## ***Interactive comment on “The Lagrangian particle dispersion model FLEXPART-WRF version 3.0” by J. Brioude et al.***

**J. Brioude et al.**

Received and published: 19 September 2013

**Fig. 1.** Vertical profile of mixing ratio of a point source emitted at the surface in a convective PBL after 3 hours of transport. Vertical profiles from each available PBL scheme in FLEXPART-WRFv3.1 are shown

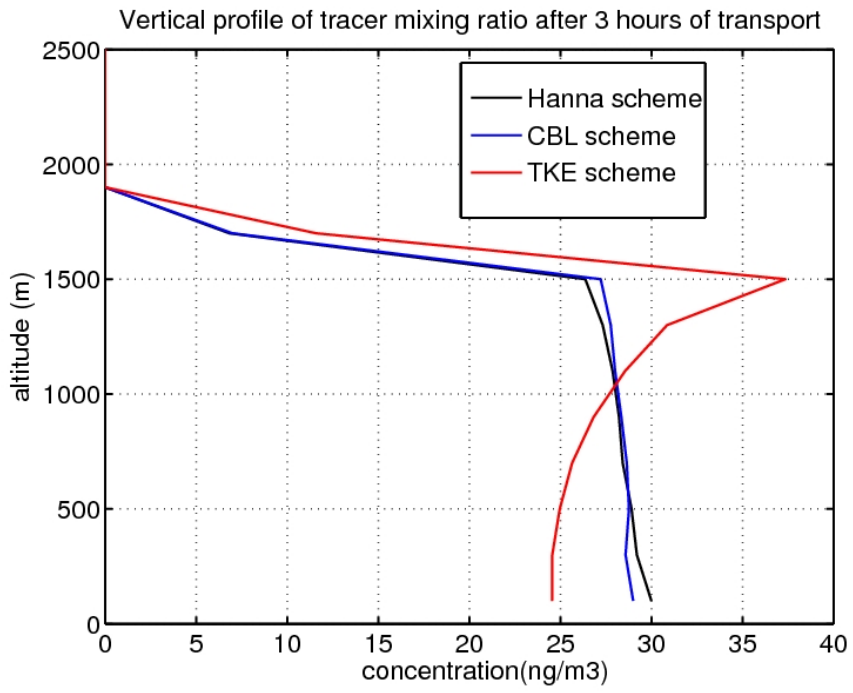
**- P3622 L15 and section 2.5 – the impact of using different PBL and turbulence output from WRF in FLEXPART could be expanded. As it stands, the options to use boundary layer and turbulence output from WRF have been implemented, but they are not recommended for use. While this may be for future scientific studies, it would be helpful to have a figure to demonstrate the differences between these options, for example for emissions from a point source in the boundary layer. It would also be helpful to compare this with FLEXPART-ECMWF/GFS.**

We added a figure (see attached figure) in the manuscript that describes the differences in vertical transport between the different schemes for a convective PBL. The reviewer will clearly notice the difference between the Hanna's scheme and the schemes that use TKE. There is no reason to compare to FLEXPART-ECMWF, which uses the same Hanna's scheme. Therefore, for the same meteorological parameters, the scheme produces the same result.
